**Seattle
Design
Commission**

**APPROVED
MINUTES OF THE MEETING
4 September 2003**

4 Sep 2003 Project: **Bitter Lake Reservoir Open Space**

4 Sep 2003 Project: Gasworks Park Staff Briefing

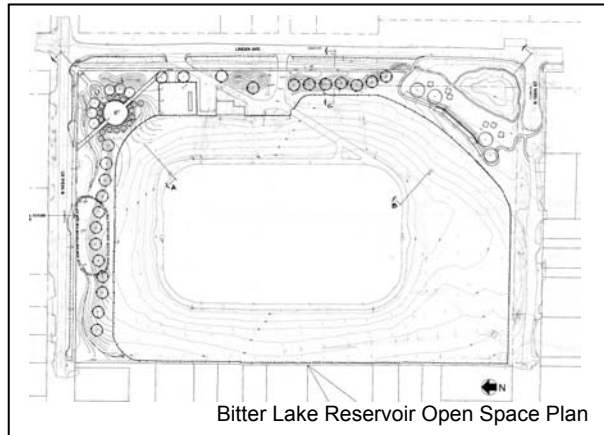
- The Design Commission applauds the evolution of this project and the clarifying and focusing of ideas, especially the poetic notion of the reservoir as a fortress of water;

- feels that the programmed uses on the site are in the appropriate locations;
- applauds the team's endurance in coordinating the work on this project among all of the involved agencies and urges them to continue to push active coordination with SPU to find an aesthetic solution for the fence surrounding the reservoir;

- suggests that the team further integrate the 3 primary design elements, including the vertical water pipe, the natural land forms, and the seating wall to reinforce the primary idea of the fortress of water;

- recommends that the team lengthen and reinforce the seating wall at the Southeast corner of the site and to look at its relationship to the adjacent path, treating the path as an element that penetrates the wall and helping to better unify the 2 corners;

- urges the team to engage the artist of the existing artwork on how best to soften or integrate the bow wave of the sculpture into the new plaza form at the Northeast corner of the site;

- applauds the intimacy of the plaza space;
- suggests that the team make use of the natural gathering point on the Northeast corner of the site to tie in to the adjacent trail; and

- recommends approval of schematic design.

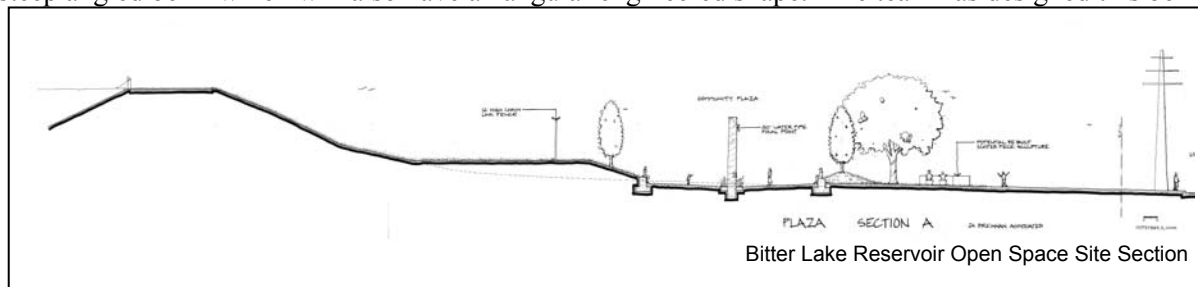
- Wonders what the paving material is on the path areas perpendicular to the sidewalk on the East side of the site.
 - Proponents explained that these are paved access paths for service vehicles. The team is working with SPU to consolidate these entrances in order to have less sidewalk crossings.

- Wonders what the infiltration pond will be like.
 - Proponents explained that it is mostly a grassy slope and is only full during a few weeks in the winter.

- Questions if people will walk in the infiltration pond.
 - Proponents stated that people currently walk in the infiltration pond so they imagine that they will continue, although this is not a typical circulation route.

- Questions if the path at the Southeast of the site needs to meander.
 - Proponents explained that this area is steeply sloped and that the path must switch direction in order to maintain an ADA accessible grade. They noted that the path could be more direct if it started further to the west.

- Suggests that the wall element could continue across more of the site even in segments as a consistent and unifying element.
 - Proponents explained that the budget limits how far this wall can be extended.

- Wonders if the project could use reclaimed concrete from SDOT projects in order to build the wall more affordably.
 - Proponents explained the labor for this type of wall is very expensive.

- Suggests that the seating wall could be extended or moved just slightly in order to work with the bend in the path and to allow the path to "break through" the wall.

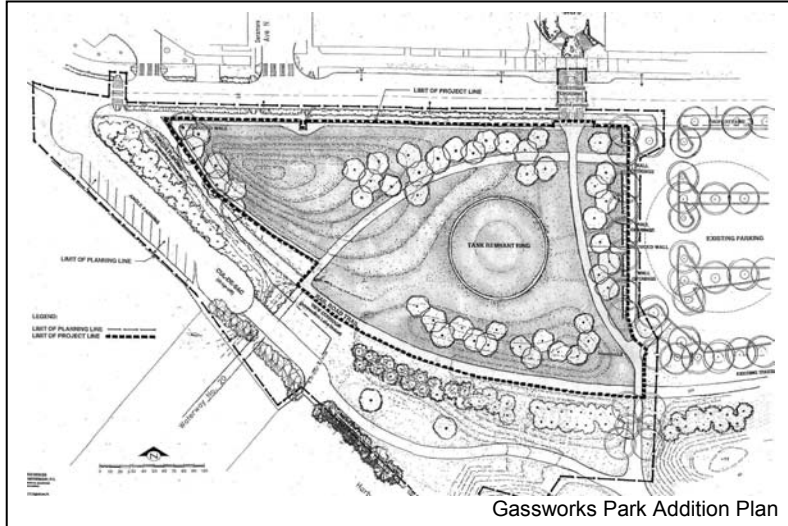
- **The Design Commission appreciates the department's efforts to examine and resolve difficult and contentious issues such as the off-leash area and the preservation of existing trees;**
- **understands the various community concerns;**
- **supports the tank remnant ring if it is pursued in the exact location of one of the existing tanks;**
- **continues to support and urges the team to consider narrowing the opening in the existing concrete wall to connect Gasworks Park to the Wallingford Steps;**
- **asks the team to consider a small opening in the wall at Densmore, as well;**
- **supports the removal of a portion of the northwest corner of the concrete wall as necessary to create a gracious entrance to the park;**
- **supports the elimination of the south curved portion of the wall; and**
- **recommends that three openings be created in the eastern wall instead of four.**

- Feels that clean cuts will show the construction of the wall. Questions if Rich Haag has an opinion about the nature of the cuts in the wall.
 - Visitors stated that Rich Haag would prefer jackhammer cuts in the wall that would reveal the texture of the aggregate and the composition of the wall.

- Is concerned that the tank ring may be a pseudo historic element. Feels that if the tank ring is pursued it should be identical in size and location to one of the historic tanks.

- Does not agree with the Friends of Gasworks Park regarding the soil removal. Feels that the proposed mounding works well with the existing park.
- Feels that the Northwest Corner of the wall is important but is concerned that keeping the wall in this location does not allow a gracious entry to the park. Suggests that the wall should be removed in this corner of the park only as is necessary to create a comfortable entrance. Notes that this opening could be smaller than what is currently being proposed.

- Notes that the connection to the Wallingford steps is extremely important. Thinks it would be inappropriate if pedestrians were faced with a blank wall at the bottom of the steps. Suggests that the opening could be slightly more constricted than the current design.

- Questions if there is lighting included in the design. Notes that street lights will cast shadows on the inside of the concrete wall.
 - Proponents stated that there is no plan for lighting within the scope of this project.
